# **Delegated Decisions by Cabinet Member for Transport Management Thursday, 17 July 2025**

## **ADDENDA**

Item 14: Ambrosden crossing - Quote:

TSRGD Diagram 1003.5

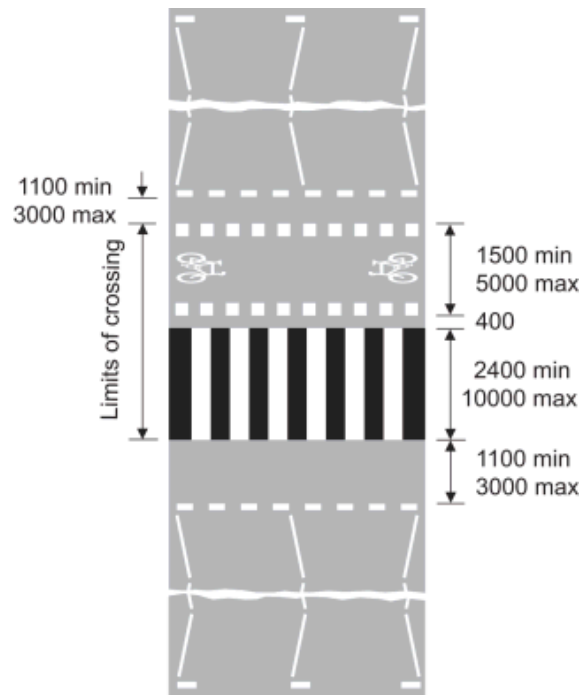
Finally, to pick up on Danny's point on colour, again from the Traffic Signs Manual Chapter 6:

Para. 17.2.4 .... Coloured surfacing may also be used to highlight the cycle route.

This *will* encourage journeys by cycling.
